LOCA at 11th and Belmont The Goat Blocks

Design Review Submittal (LU# 14-125908 DZM AD) (DAR# 13-224797) (Pre-Application# EA-203772)

PRESENTED BY: KILLIAN PACIFIC
OWNER: BELMONT INVESTMENT, LLC
ARCHITECT: ANKROM MOISAN ARCHITECTS
06.30.2014

Design Updates & Comment Responses

**North Block
Grocery Building**

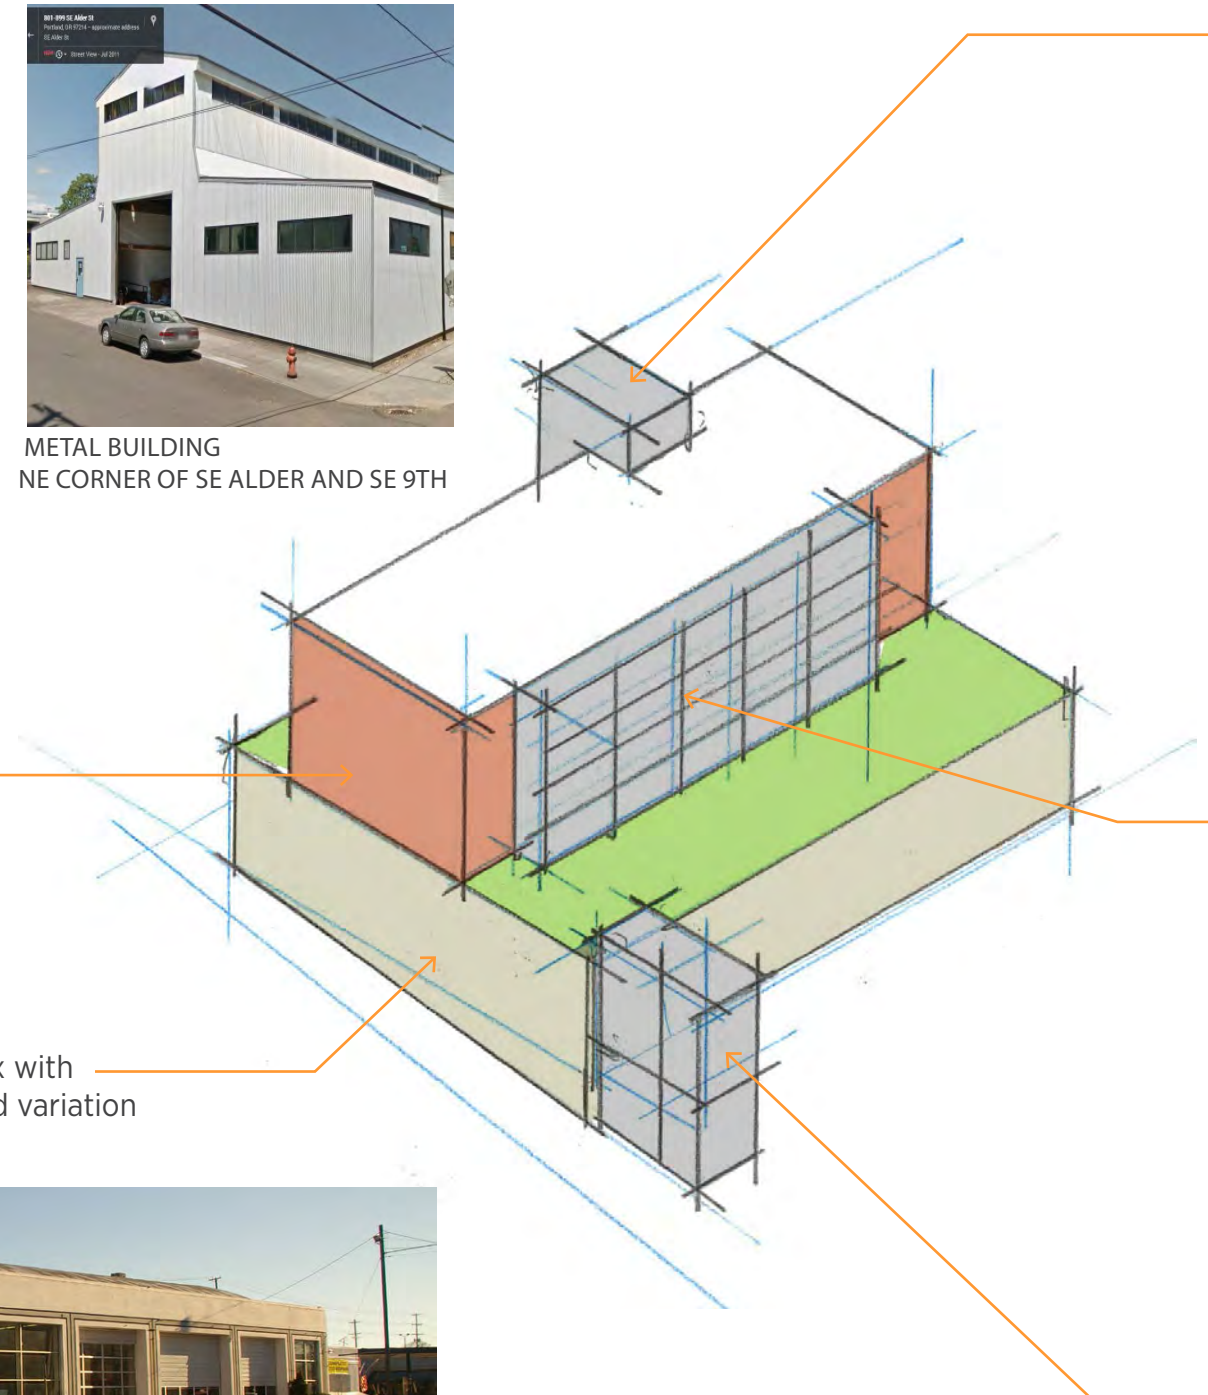
1. Design Concepts
 - Explain design concepts of building
2. Material Palette
 - Simple, too many materials
 - Corten Steel not appropriate
3. 11th and Belmont Grocery entry
 - Too small
 - More bike parking
4. Belmont elevation
 - Add more glazing too meet requirements
 - RACC involvement Unclear
5. Exterior screens at upper housing floors to narrow and questioned horizontal orientation
6. Transom Windows above bays-scale is wrong
7. Hooded exhaust venting not well integrated.

Steel Plate Panels removed at grocery entry

Corten steel at Elevator removed

Corten steel at steps removed

Large, Brick Framed opening at grocery entry - simplifies building form

Steel Plate Panels at Elevator- Simplifies Material Palette

Simplified stairs and Simplified material palette at stairs

Bike Parking added near vertical stairs

after (C.116) changed from vent hood

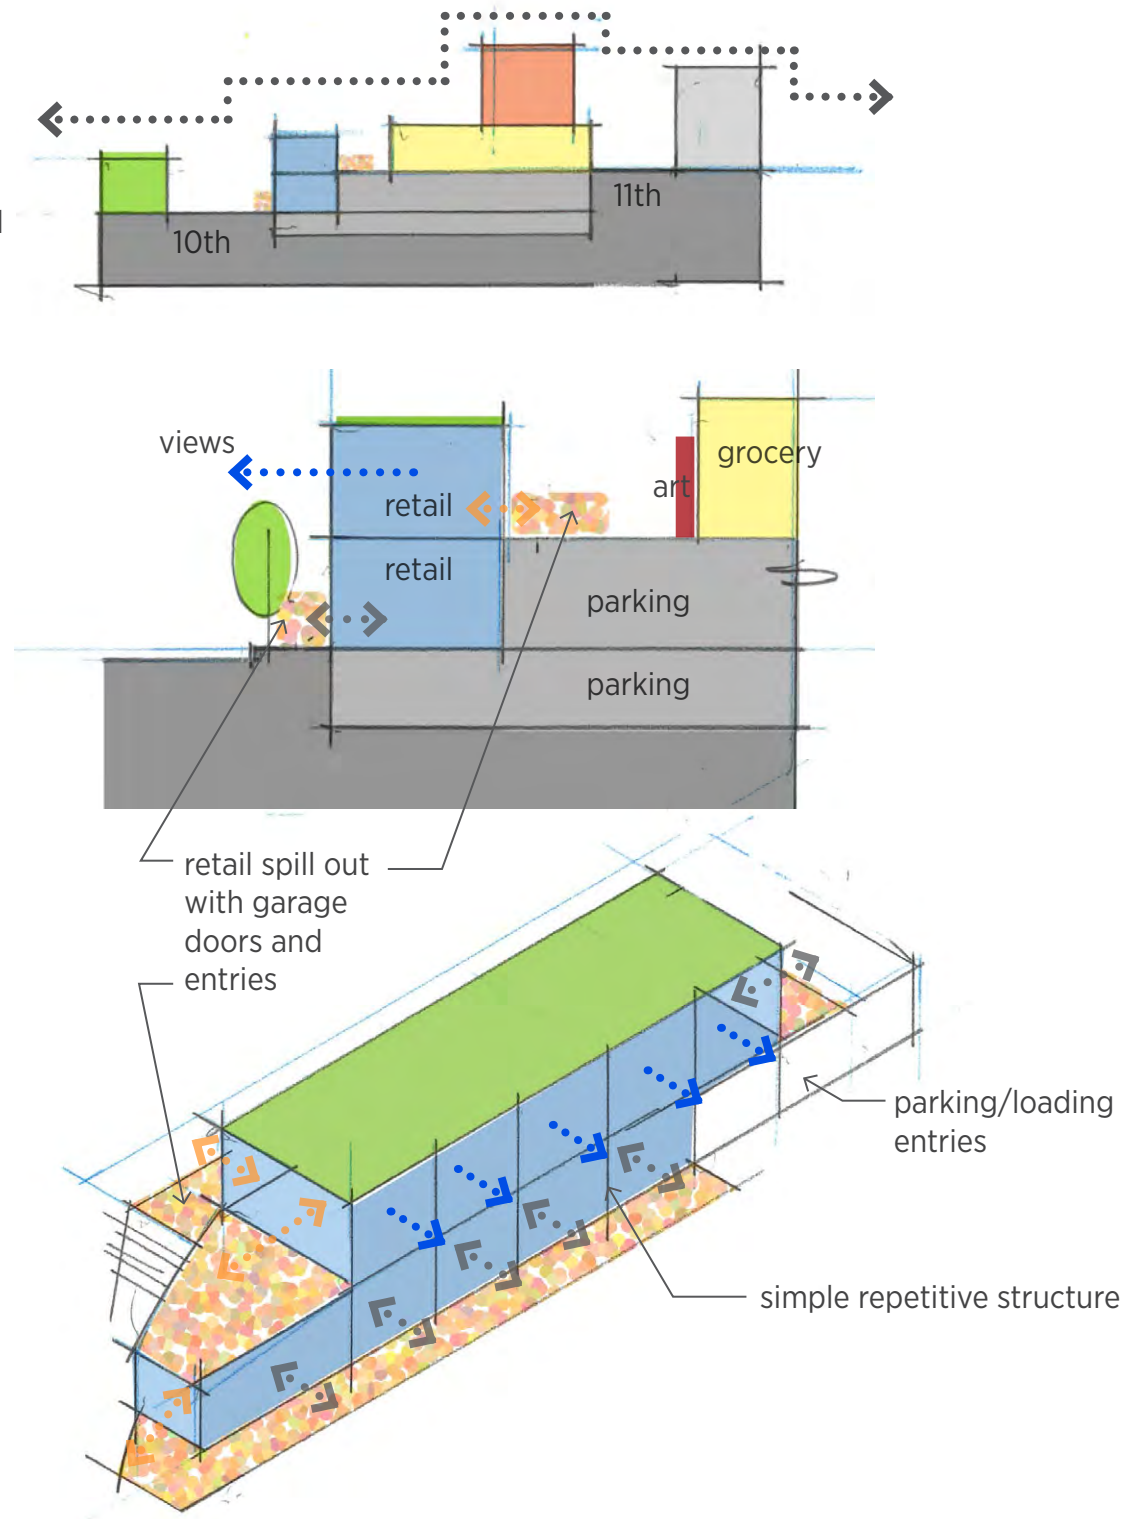
1. Design Concepts
 - Explain design concepts of building
2. Material Palette
 - Simply, too many materials
 - Corten Steel not appropriate
3. 11th and Belmont Grocery entry
 - Too small
 - More bike parking
4. Belmont elevation
 - Add more glazing to meet requirements
 - RACC involvement Unclear
5. Exterior screens at upper housing floors to narrow and questioned horizontal orientation
6. Transom Windows above bays scale is wrong
7. Hooded exhaust venting not well integrated.

horizontal screen changed

screens widened

perforated screen material

1/2" Holes on 11/16" Staggered Centers
48% Open Area

before (C.25)

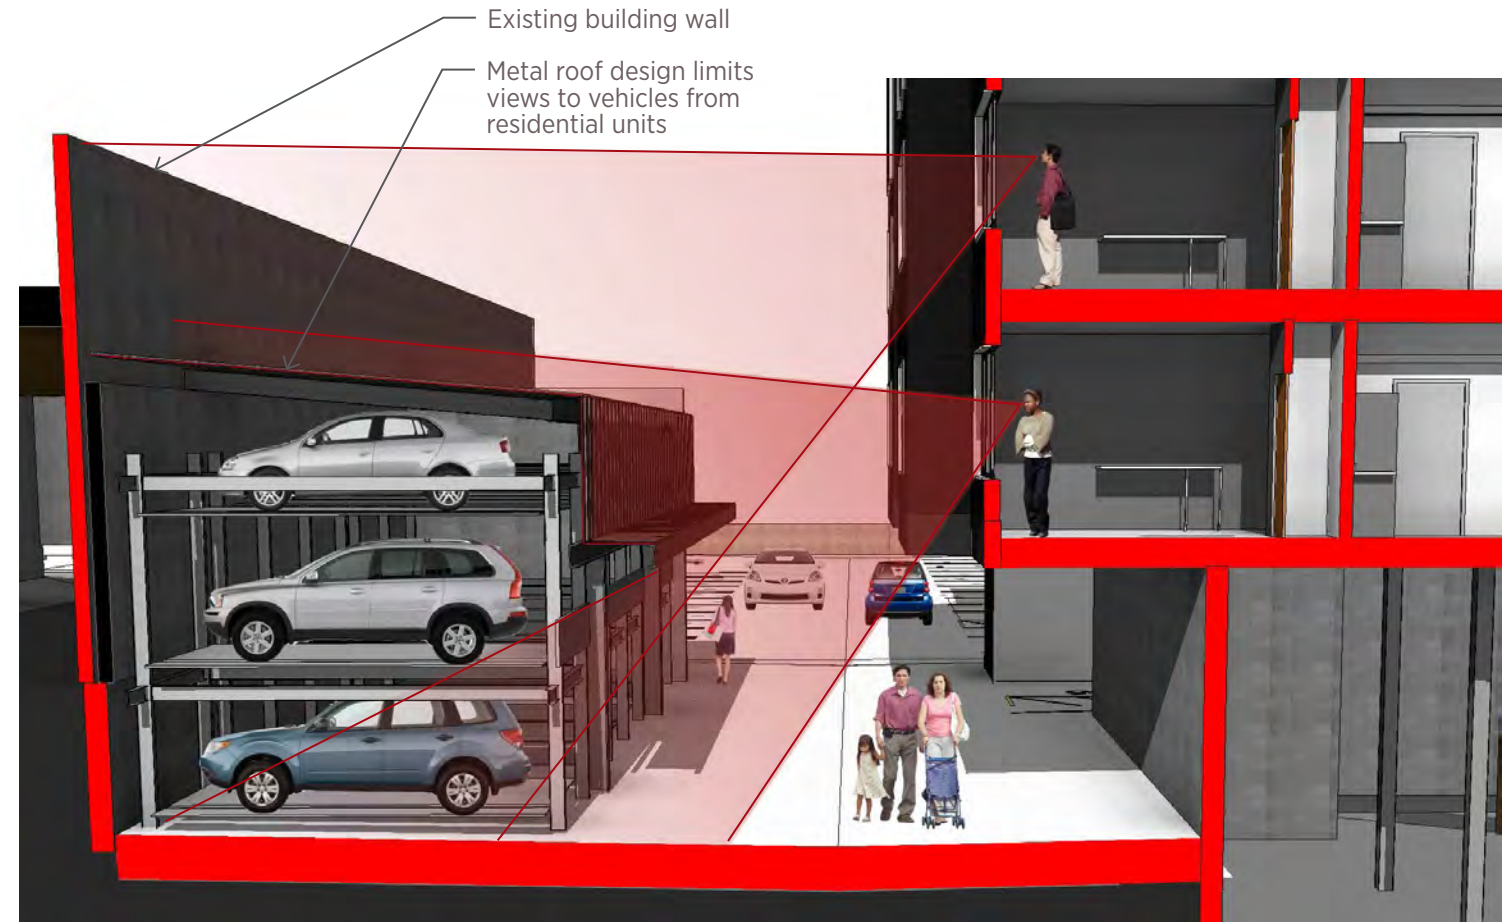
1. Decks
 - remove or add more
2. Parking behind building needs to be covered

Decks removed from West elevation

before (C.33)

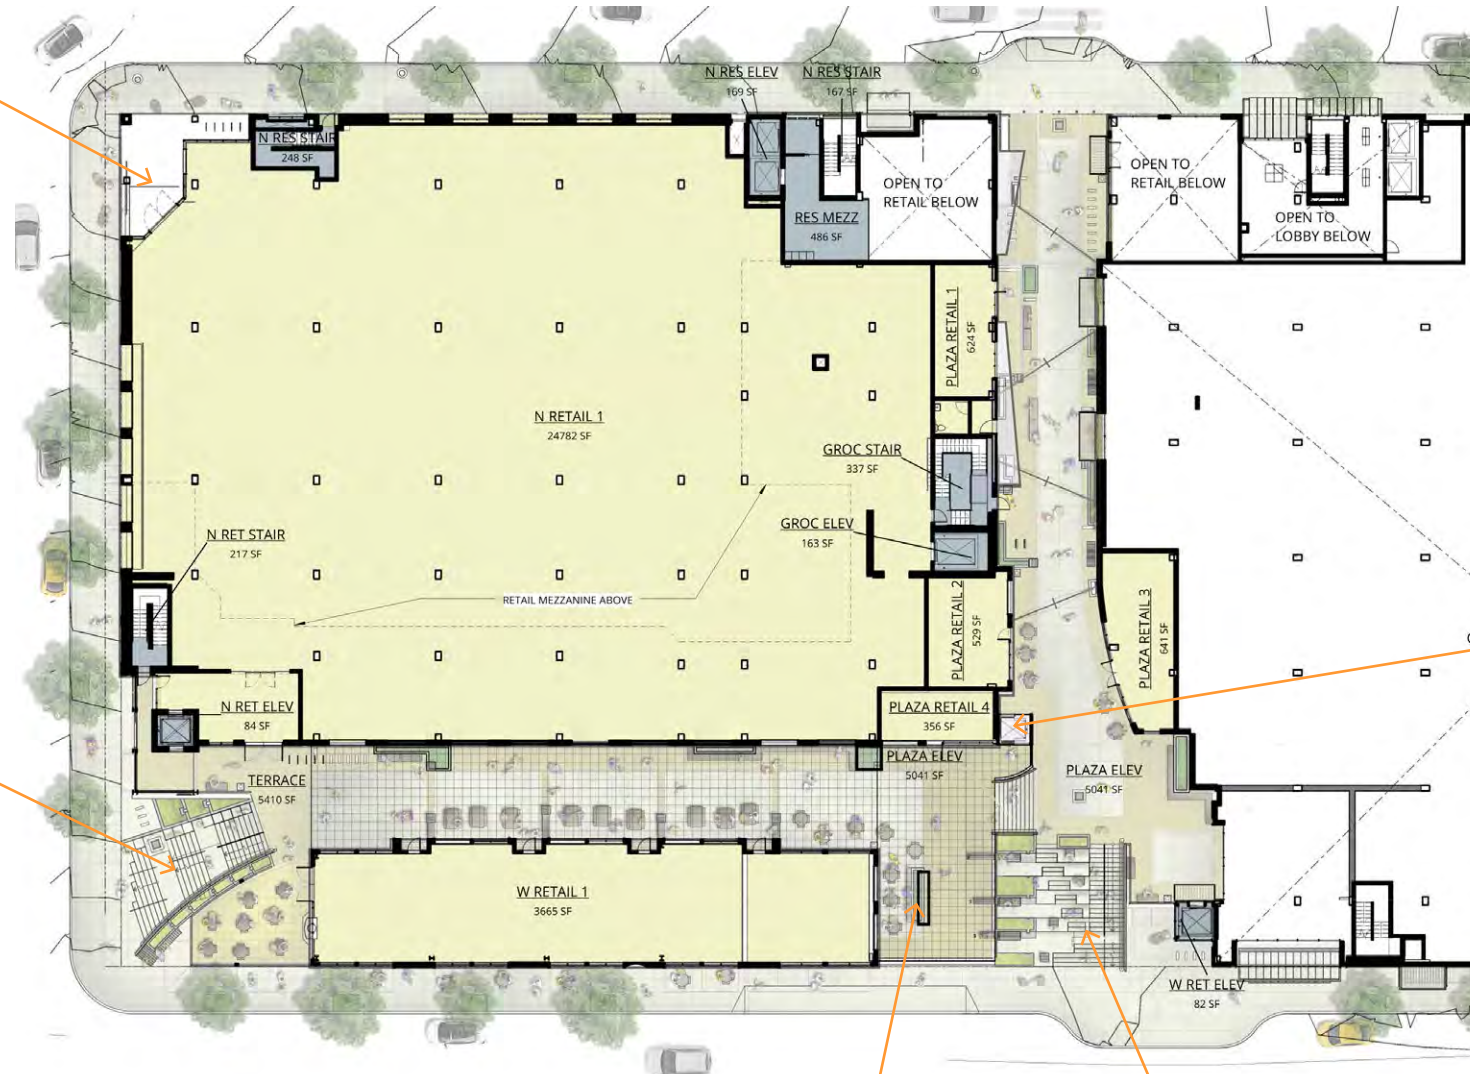
1. Make spaces dynamic
2. Provide common thread
3. More consistency
4. Spaces feel "small"
5. Spaces feel under designed
6. Re-organize Yamhill Steps
7. Belmont Stair is good
8. Material Palette
 - Simplify, too many materials
 - Don't use Corten steel
 - Too many light fixture types
 - Too many handrails
9. Remove Cylinder light fixtures

Cylinder lights removed

Re-organized Yamhill Stairs and increased area of Superblock Plaza

Corner opened up, additional bike parking and retail spill out opportunity added,

10th and Belmont stairs simplified and corten removed, Simplifies Materials Palette

Retail and trellis removed to create larger more open Superblock Plaza area

Yamhill Stairs widened and simplified

Elevator Lift relocated to Open up plaza more

10th and Belmont Stairs before (C.19)

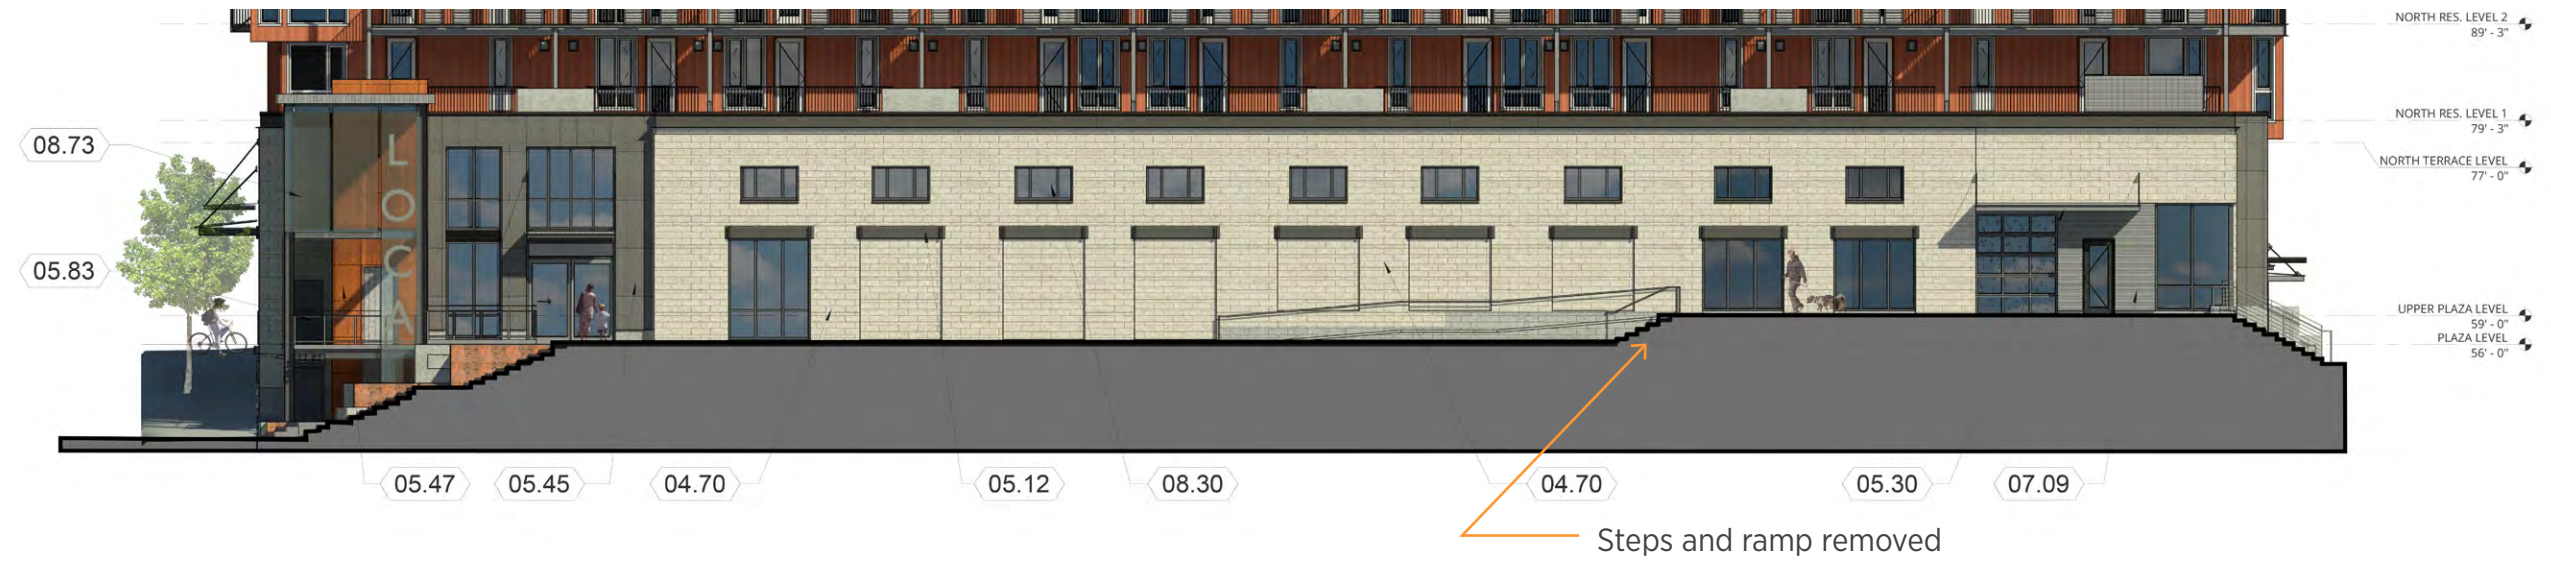
1. Make spaces dynamic
2. Provide common thread
3. More consistency
4. Spaces feel "small"
5. Spaces feel under designed
6. Re-organize Yamhill Steps
7. Belmont Stair is good
8. Material Palette
 - Simplify, too many materials
 - Don't use Corten steel
 - Too many light fixture types
 - Too many handrails
9. Remove Cylinder light fixtures

Stairs simplified, Corten removed
Simplifies Materials Palette

Bike Racks added
